# NEWMAR CORPORATION WARRANTY DEPARTMENT

## TECHNICAL SERVICE BULLETIN

RE: Notice of Campaign Service Bulletin: **CSB13-350-001**

CSB13-350-001

**FIG. 2-1**

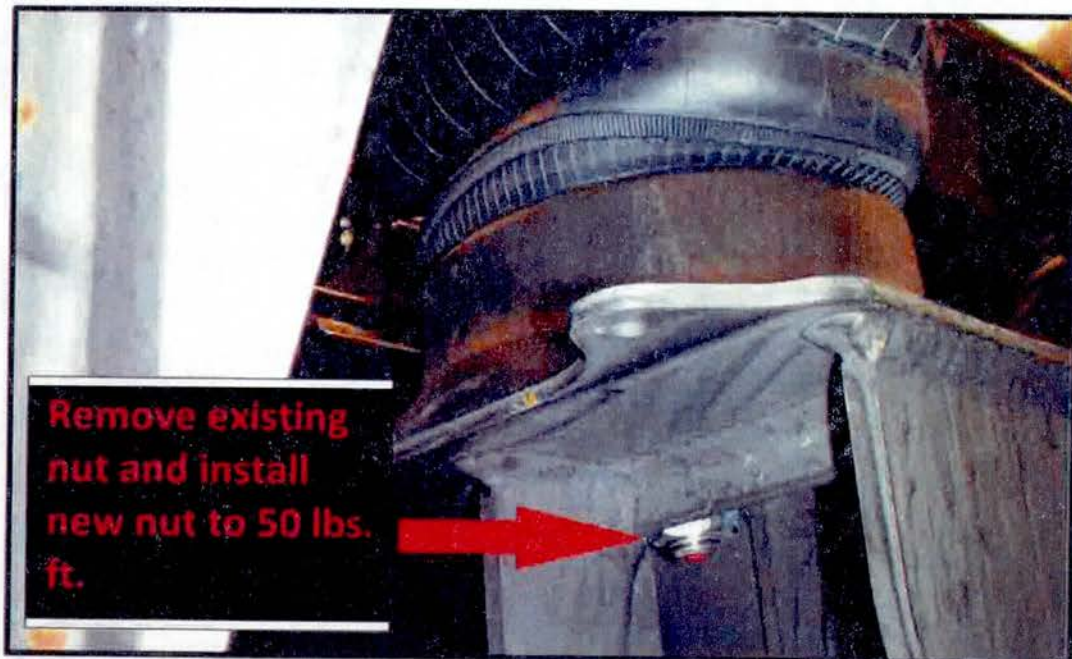
**CONDITION:** Air spring retainer fastener may loosen on certain K3 chassis.

1. Bring up the vehicle to ride height. Once at ride height using industry standard practices set jack stands under the frame rail.
2. Locate the six Ridewell rear suspension air springs. Remove the existing bottom nut on each of the air springs.
3. Using provided hardware install new nut on each air spring. Torque the bottom nut to 50 lbs. ft. Refer to FIG. 2-1.

**NOTE: The existing nut is thinner in appearance than a jam nut. The new nut is thicker in appearance and a lock nut.**

**CORRECTION:** Replace locking nut on Ridewell® air spring.
